## PATENTS ACT 1977

APPLICANT	Othman Bin Ahmad
ISSUE	Whether patent application GB1521173.3 complies with sections 1(1)(c) and 14(5)(b) and (c) of the Act
HEARING OFFICER	B Micklewright

### DECISION

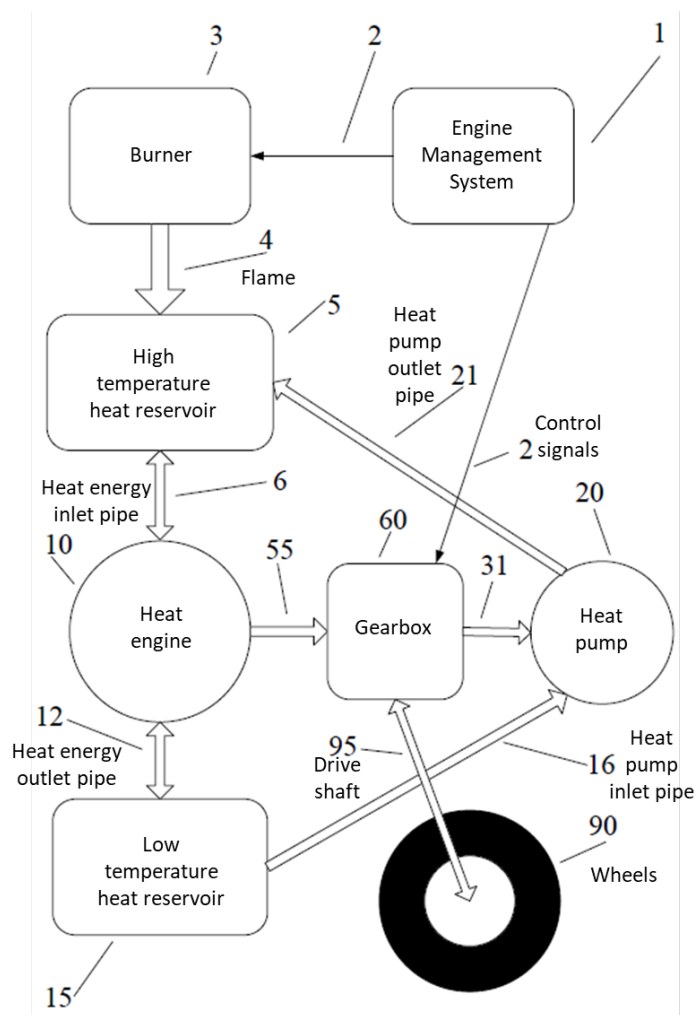
10 This is a lengthy claim, and the following drawing from the application may aid understanding.

- 30 The second issue I discussed with Mr Ahmad at the hearing regards the frequent use of the word “plurality” in claim 1. It became clear during my discussions with Mr Ahmad that he was under the misapprehension that “plurality” means “one or more”. It is commonly accepted that it means “two or more” and that is how the skilled reader would interpret it. The power system of claim 1 is said to have a plurality of

heat engines, a plurality of heat pumps, a plurality of burners, a plurality of high temperature reservoirs and so on. The problem here is that there is nothing in the description which suggests there to be a plurality of these components in the power system. Mr Ahmad put it to me that the embodiments are just examples which illustrate the invention, and it would be quite possible to have a system that used, for example, two heat engines at the same time, pointing out that twin-engine vehicles do exist. However, there is no disclosure of such in the description. Furthermore, the described embodiments fall outside the scope of claim 1 since they only have one of each of the components, and the claim requires there to be at least two. There is evidently a support issue here which will need to be addressed; the claims are at odds with the description. The issue also occurs elsewhere in the claim set.

- The use of the term “plurality” in claim 1 to define the number of heat engines, heat pumps, etc, causes the claim to be inconsistent with the description and therefore is unclear and lacks support.
